VIRGINIA ELECTRIC AND POWER COMPANY  
RICHMOND, VIRGINIA 23261

Serial No. 446A  
PO&M/TAP:wbh  
Docket Nos. 50-280  
50-281  
License Nos. DPR-32  
DPR-37

REFERENCE: "Pressure Mitigating Systems Transient Analysis Results", July 1977. (Westinghouse Report on RCS Solid Water Over-pressurization)

Attached are three revised figures which should be substituted for the corresponding figures to be found in Appendix B of Reference 1. The revisions accommodate modifications made to the letdown isolation transients represented in these figures to upgrade the analytical basis and account for an input data correction.

FIGURE M6  
REVISED

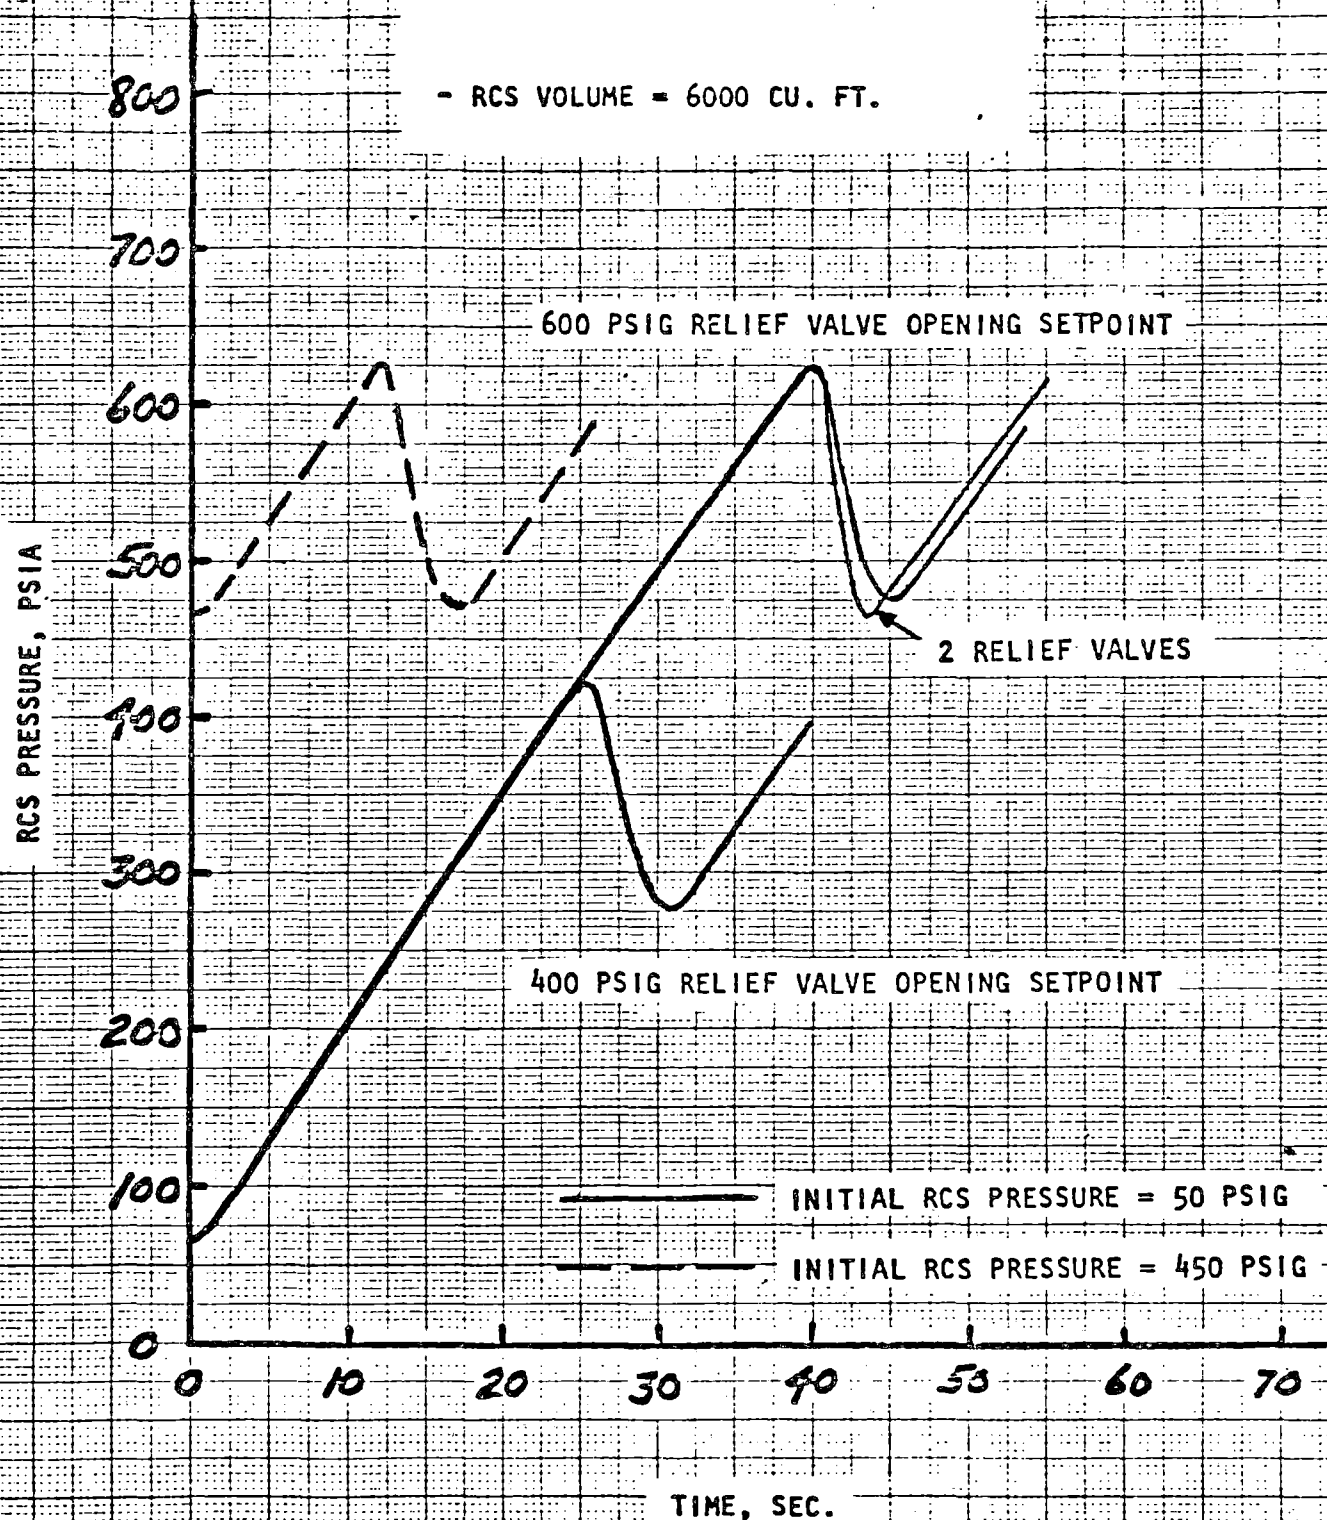
In both Figures M6 and M10, the common transient exhibiting RCS setpoint pressure undershoot response for two relief valve operation at a setpoint of 600 psig has been replotted to reflect valve closure at a reset pressure 20 psi below the setpoint. The original transient depicted in Figure M6 and Figure M10 of Reference 1 (Appendix B) represented valve closure at a reset pressure 120 psi below the 600 psig setpoint. As would be expected, the setpoint pressure under shoot has been significantly reduced to the extent that violation of the RCS pump seal pressure limit is no longer a consideration for this transient.

RCS PRESSURE TRANSIENT  
FOR ONE CYCLE OF RELIEF  
VALVE OPENING AND CLOSING

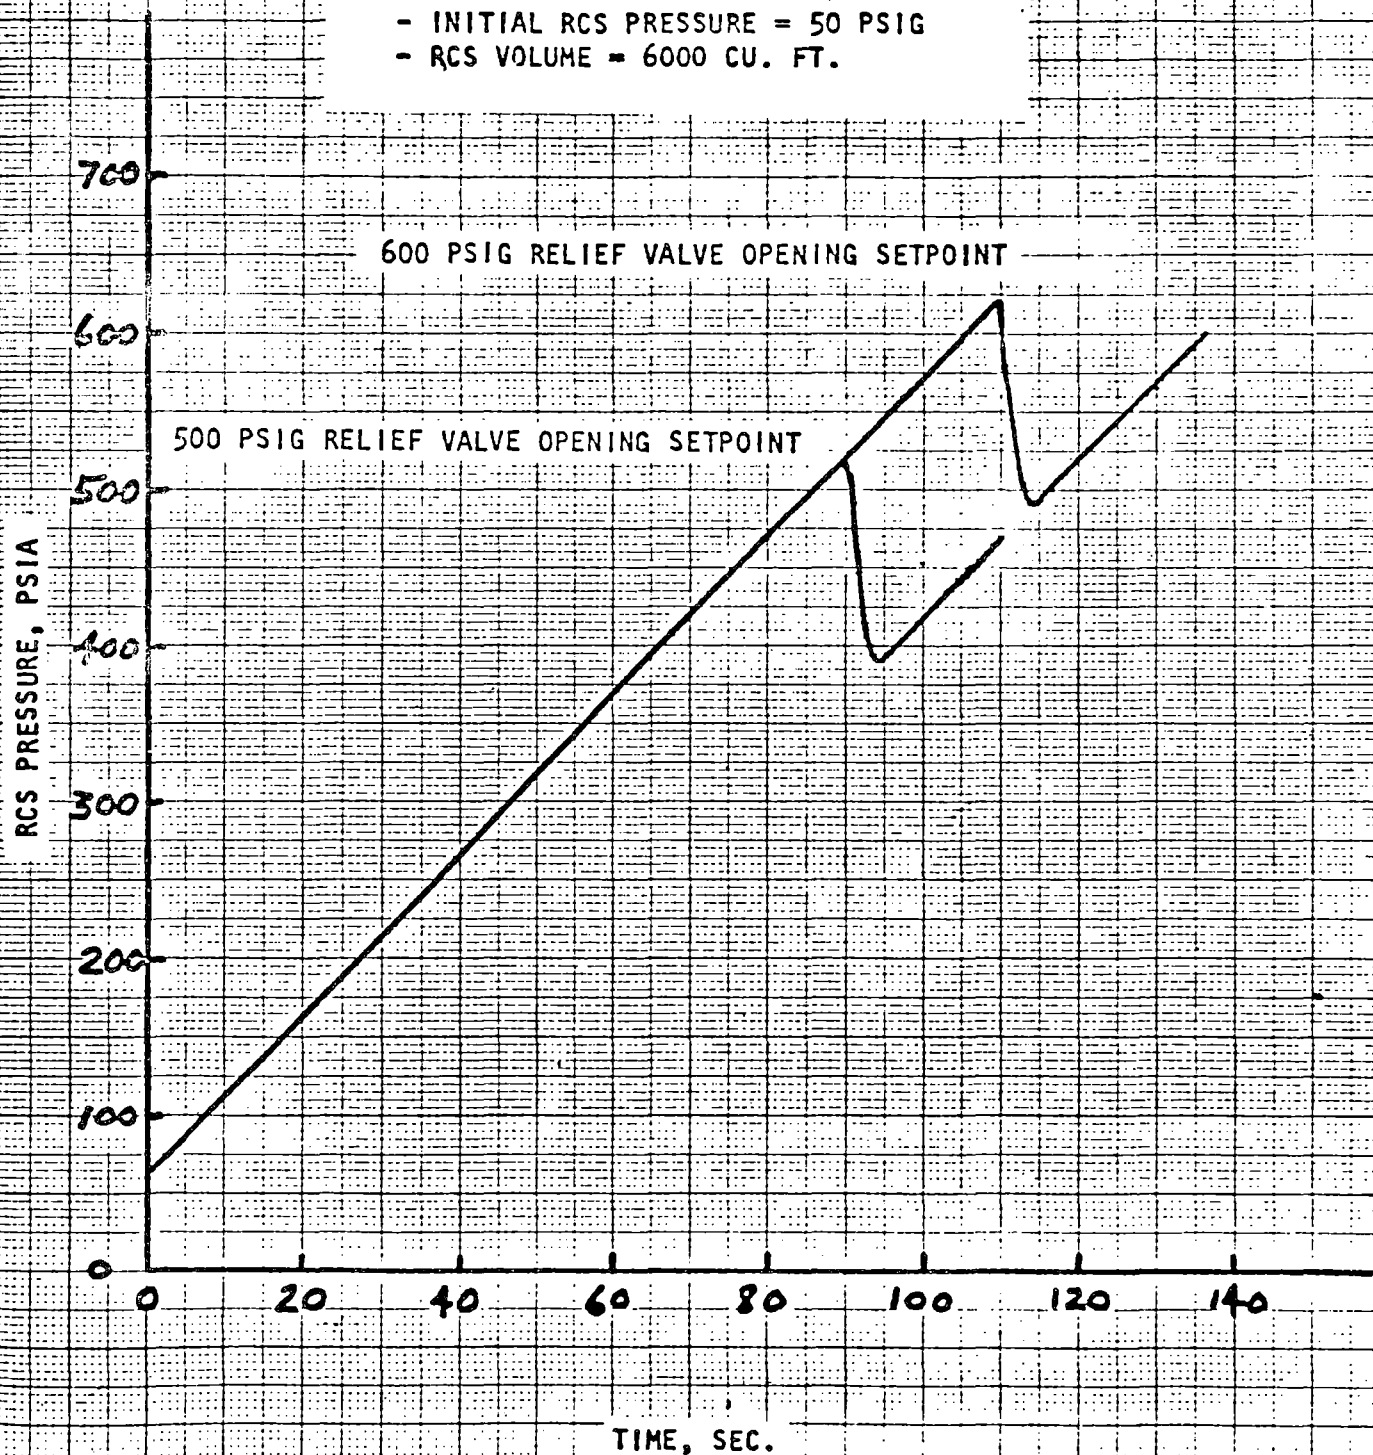
In Figure M7, the setpoint pressure undershoots for both the 500 psig and 600 psig relief valve setpoint transients have been adjusted to reflect a correction to the LOFTRAN input data. A reduction in setpoint pressure undershoot is evident in both transients.
